ADDENDUM NO. 7

HVAC & CONTROLS REPLACEMENT/ADDITION AT NINE (9) SITES: BARRANCA, BEN LOMOND, CYPRESS, GROVECENTER, MANZANITA, MERWIN, MESA, ROWLAND, AND WORKMAN ELEMENTARY SCHOOLS RFQ/RFP #22-23-105

January 19, 2023

4 BUILDING E MECHANICAL FLOOR PLAN
M1.1C / SCALE: 1/8" = 1'-0"

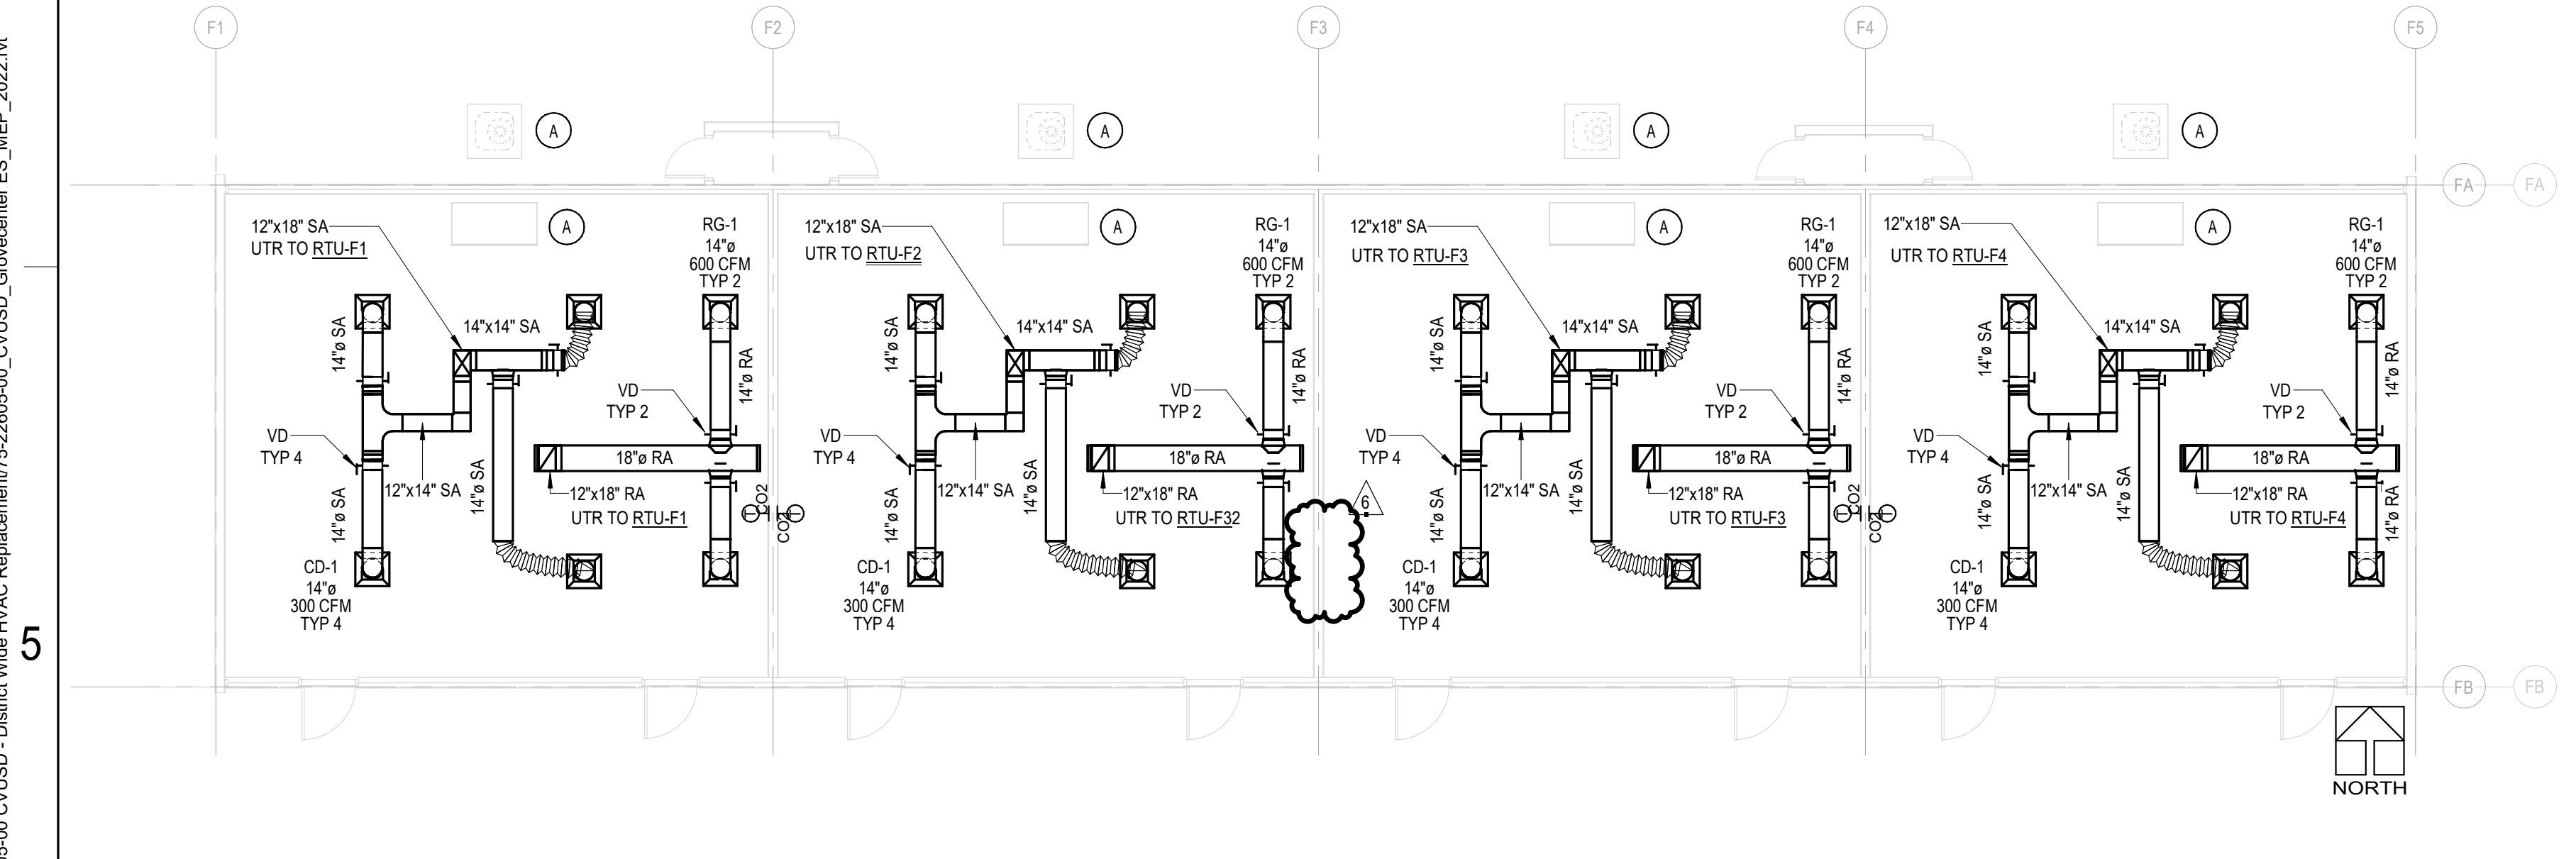
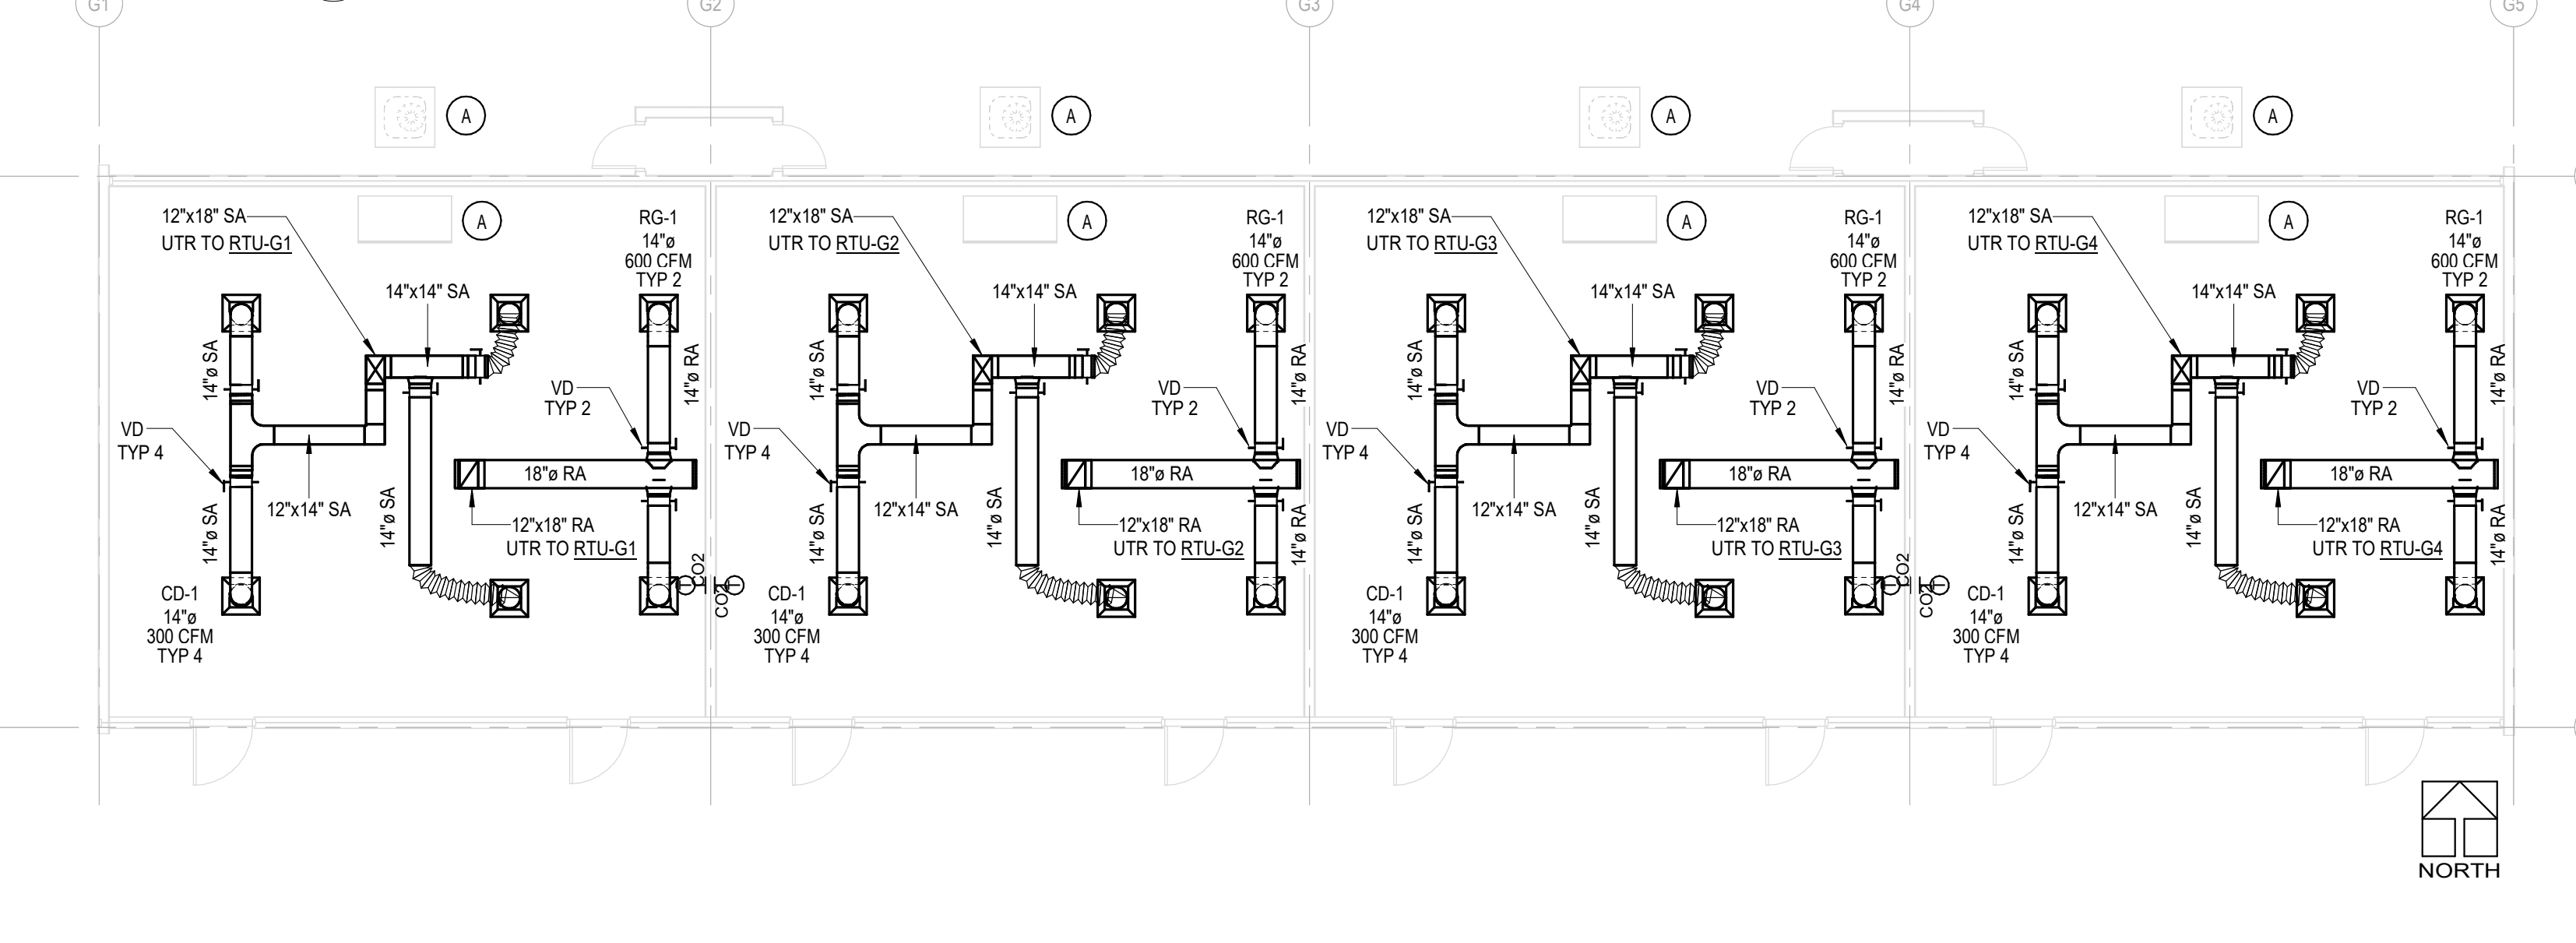
(Page M1.1C)

-Building F: GL F3- There is an extra set of Co2/T-Stat per the plans. Please confirm if RTU F2 and RTU F3 Co2s/T-stats are to be on GL F2 and F4 walls.

DLR Response: See attached updated drawing M1.1C
